## CORPORATION OF THE TOWNSHIP OF ESQUIMALT

### DESIGN REVIEW COMMITTEE AGENDA

##### **616 and 620 Lampson Street**

## STAFF REPORT

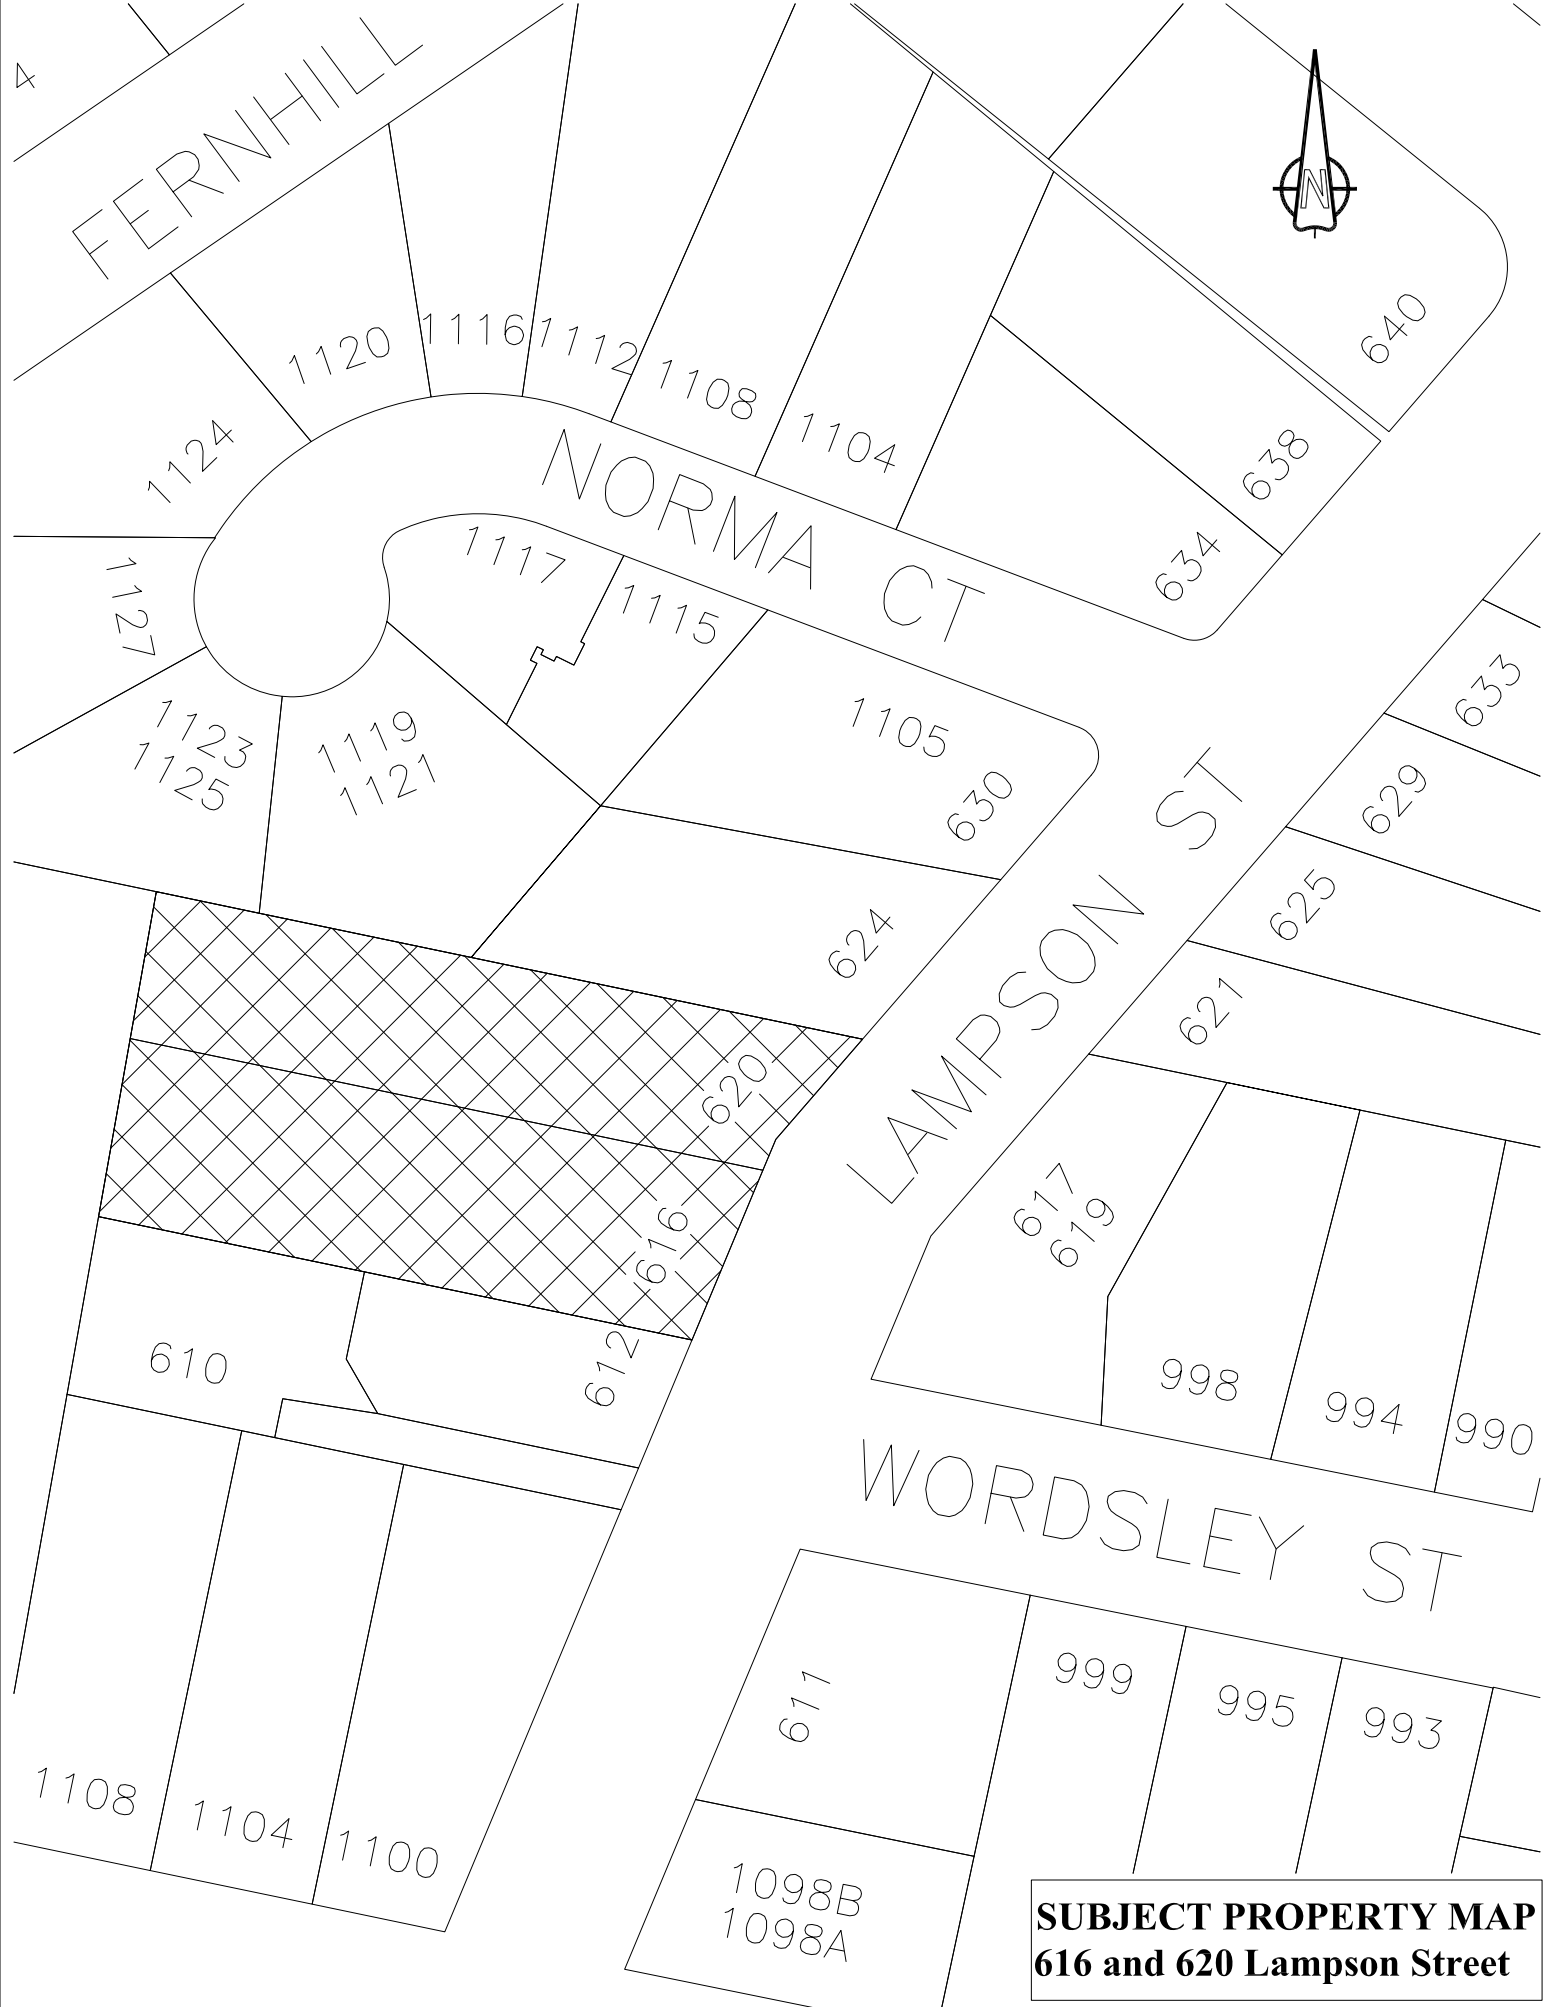
The following design guideline; which was written into CD No.97 as a result of comments raised by the Design Review Committee (November 12, 2015), has been achieved.

The Principal Building will have a general character that shall modulate at approximately 0.8 metre offsets at approximate 9 metre (30 foot) increments, generally as illustrated on the following diagram.
